## Response to the reviewers' comments (3) on HESS-2009-213

Dear Dr. Hrachowitz,

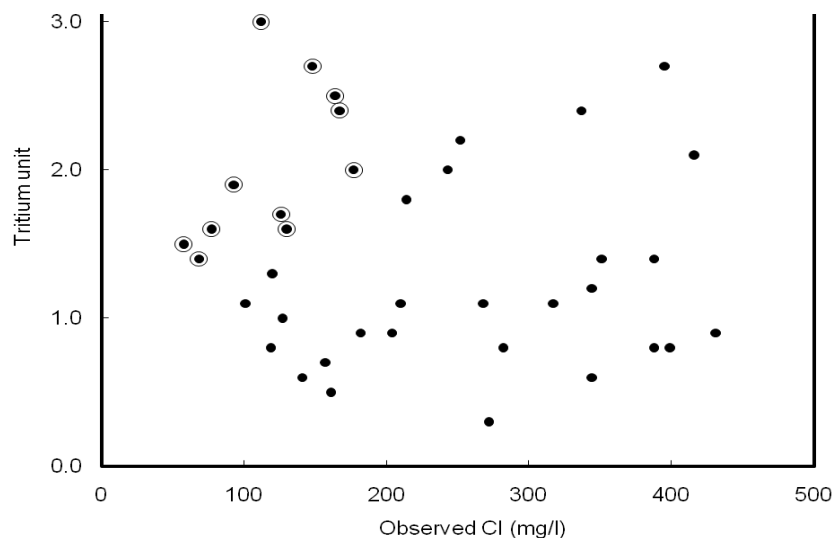
*14) P7039,L.10: Please justify the range of 25-125 mg/l. Although the authors assumption that recent recharge water should show lower concentrations seems sound, the chosen range still seems somewhat arbitrary.*

This range is defined as to the left of the mode in the histogram. We tried to use the tritium data to distinguish recently recharged water. It looks like

If the circled points (higher TU, but lower Cl concentration) are used for the mean chloride concentration, the geometric mean gives 110 mg/l. But the most dilute sample without Tritium measurement was not included in this calculation. If it is included, the geometric mean is 100 mg/l. But even this, we have to justify. Another method currently in development, based on principal component analysis, gives a geometric mean of 90 mg/l. But the methodology is too complex to be included here. Nevertheless, the three methods come to similar mean groundwater chloride concentration, supporting the estimates based on the histogram.

We will give some justification in the revision. And the geometric mean will be applied for calculating the mean, as suggested by another reviewer.
